APPLICATION TO THE ZONING BOARD OF ADJUSTMENT

48 Waterman Avenue
Property Address
139
Block
8
Lot

Denial Memorandum

Applicant: Michael McClusky
Address: 48 Waterman Avenue, Rumson, NJ 07760
Block 139, Lot 8, Zone: R-5

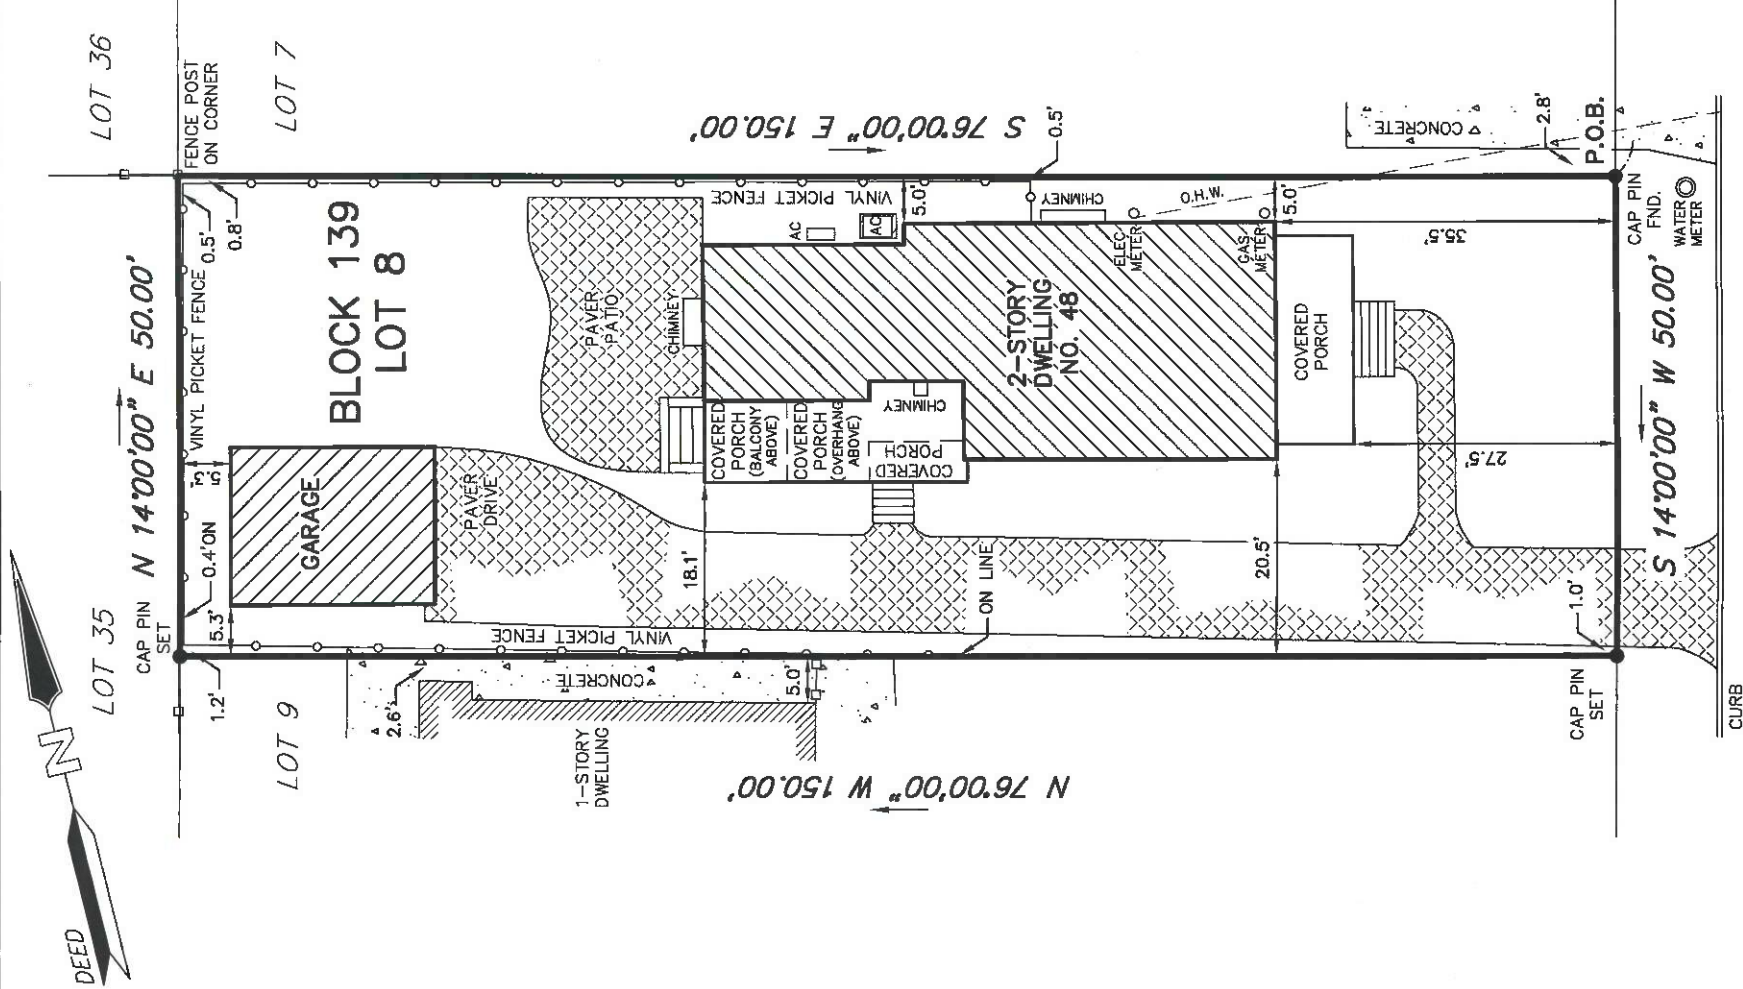
I have reviewed the revised Land Use & Development Permit application for improvements at 48 Waterman Avenue in Rumson. The existing lot is conforming in size and shape. The principal dwelling is nonconforming due to the existing side yard setback of 5'. The proposed improvements include the house lift, porch enclosure, additions, new rear deck and existing garage removal.

As per Borough Ordinance 22-7.3f, relating to nonconforming buildings, a nonconforming building may not be enlarged, extended, increased in height, width or depth; moved or relocated; or modified in such a way so as to increase habitable or usable space unless it is changed to conform and/or the enlargement, extension or addition conforms to all requirements of this chapter and will not result in the creation of any new nonconformities. Therefore, the application was **denied** for the following:

- Lifting dwelling while maintaining side yard setback and front porch nonconformities (**Existing nonconformities – Intensified**).
 - Principal dwelling SYSB of 3.5', whereas 8' is required.
 - Front porch SYSB of 7', whereas 8' is required.
 - Front porch FYSB of 27.5' whereas 30' is required.
- Proposed rear raised deck with rear setback of 43' whereas 45' is required. (**New**)
- Entry steps in a flood zone are permitted to extend an additional 10' in the FYSB and 5' in the RYSB. The following nonconformities require variances (**New**):
 - Front steps setback at 22.1' whereas 25' is required.
 - Rear steps setback at 39' whereas 40' is required.
